Docket Number:	87-AFC-01C
Project Title:	COMPLIANCE-Luz Solar Electric Generating System Cogeneration AFC (150 MW) Units III-VII.
TN #:	243049
Document Title:	Staff Analysis-Boundary Modification
Description:	Staff Analysis of Petition to Amend the Final Commission Decision
Filer:	susan fleming
Organization:	California Energy Commission
Submitter Role:	Commission Staff
Submission Date:	5/13/2022 9:08:08 AM
Docketed Date:	5/13/2022

SUBJECT: Solar Energy Generating System, Units III- VII Kramer Junction (87-AFC-01C)
Staff Analysis of Petition to Amend the Final Commission Decision

SOLAR ENERGY GENERATING SYSTEM (SEGS) UNITS III-VII KRAMER JUNCTION (87-AFC-01C)

Petition to Amend Commission Decision EXECUTIVE SUMMARY

Executive Summary Figure 1

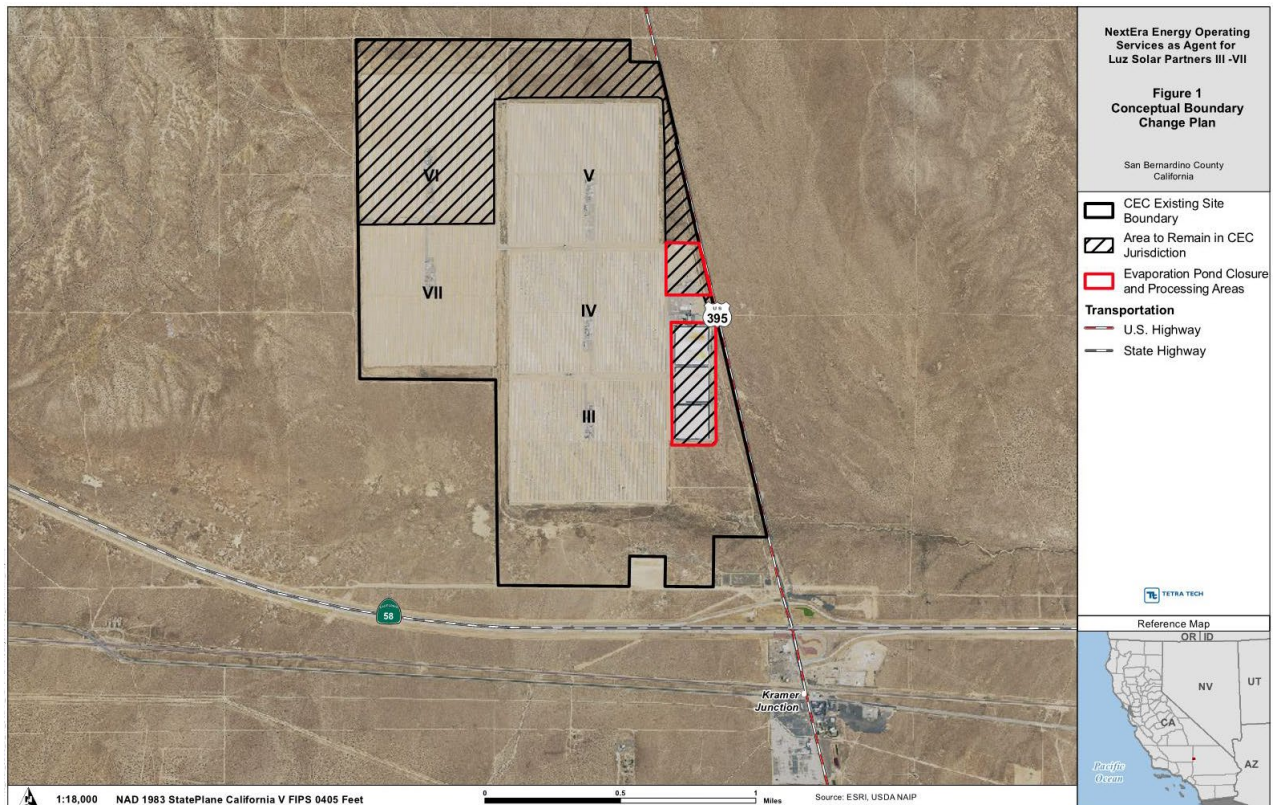
The post certification project change requests a boundary modification of the site identified in the Decision to exclude and remove the area previously occupied by the SEGS Unit VII as shown in **Executive Summary Figure 1**. All decommissioning activities within the areas previously occupied by the SEGS Units III – V and VII have been completed in accordance with the approved Facility Plan and with all applicable conditions of certification (COCs) contained in the Decision. The purpose of the boundary change is to allow a new solar photovoltaic (PV) project to begin construction pursuant to a permit issued by San Bernardino County while the remaining decommissioning activities for SEGS Unit VI continue to completion. San Bernardino County issued a notice of exemption in conjunction with the permitting of the PV facility. (See http://www.sbcounty.gov/Uploads/LUS/Environmental/NOEs/NOE_PROJ_2021_00019.pdf)
